# Product Safety Recall

## N212330040 Driver Seat Belt Cable May Separate

Release Date: April 2021

4551063

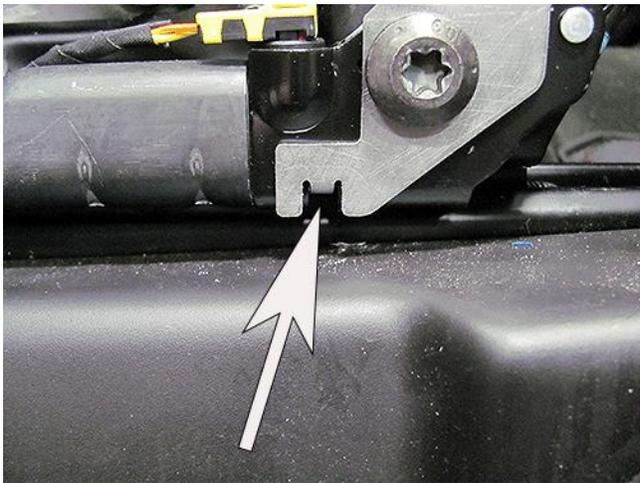
**NOTE:** If a tensioner bracket was installed as part of a previous service, discard the bracket. The new replacement front seat belt anchor plate tensioner design eliminates the need for the bracket.

1. Replace the driver side front seat belt anchor plate tensioner. Refer to *Front Seat Belt Anchor Plate Tensioner Replacement* in SI.
2. Scrap the removed driver side front seat belt anchor plate tensioner. Refer to *Front Seat Belt Anchor Plate Tensioner Replacement* in SI.

4551063

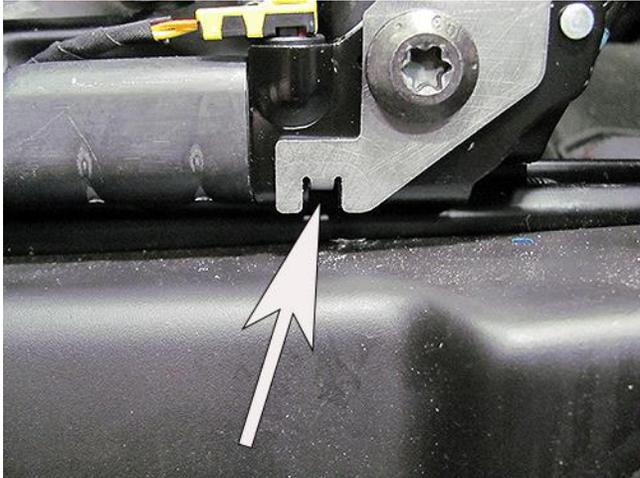
**NOTE:** If a tensioner bracket was installed as part of a previous service, discard the bracket. The new replacement front seat belt anchor plate tensioner design eliminates the need for the bracket.

1. Remove the driver side front seat belt anchor plate tensioner. Refer to *Front Seat Belt Anchor Plate Tensioner Replacement* in SI.
2. Transfer the seat switch (if equipped) and hardware onto the new seat side shield panel. Refer to *Front Seat Cushion Outer Finish Cover Replacement* in SI.
3. Complete the installation of the new seat belt anchor plate tensioner and new seat cushion outer finish cover. Refer to *Front Seat Belt Anchor Plate Tensioner Replacement* in SI.
4. Scrap the removed driver side front seat belt anchor plate tensioner. Refer to *Front Seat Belt Anchor Plate Tensioner Replacement* in SI.
